# Service Update

## 16195 Brake Lamps Remain Activated

Reference Number: N162068110

Release Date: January 2017  
Revision: 00

4671098

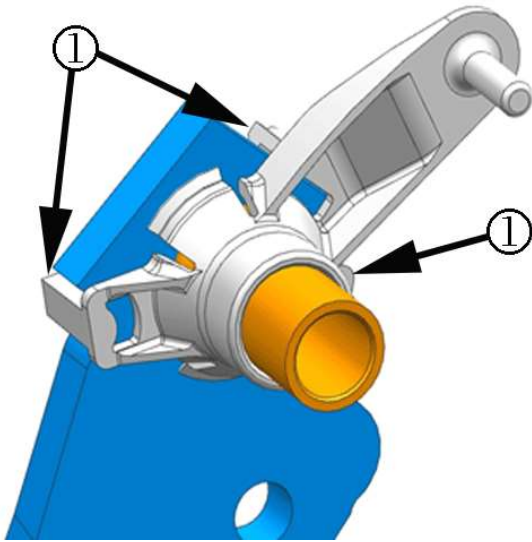
1. Gain access to the brake pedal position sensor (BPPS) switch activation bracket (1).

4671106

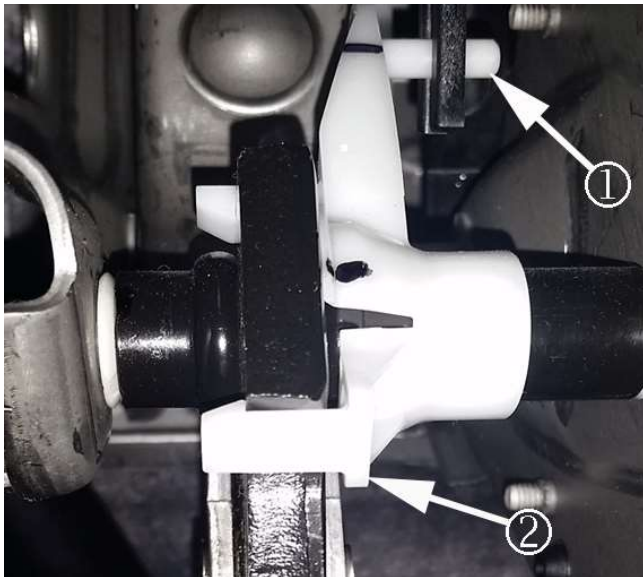
2. Ensure all three BPPS switch activation bracket plastic tabs (1) are secured over the pedal arm.
  - If all three BPPS switch activation bracket plastic tabs are secured over the pedal arm, proceed to the next step.
  - If any of the BPPS switch activation bracket plastic tabs are NOT secured over the pedal arm, secure the BPPS switch activation bracket tabs over the pedal arm and proceed to the next step.
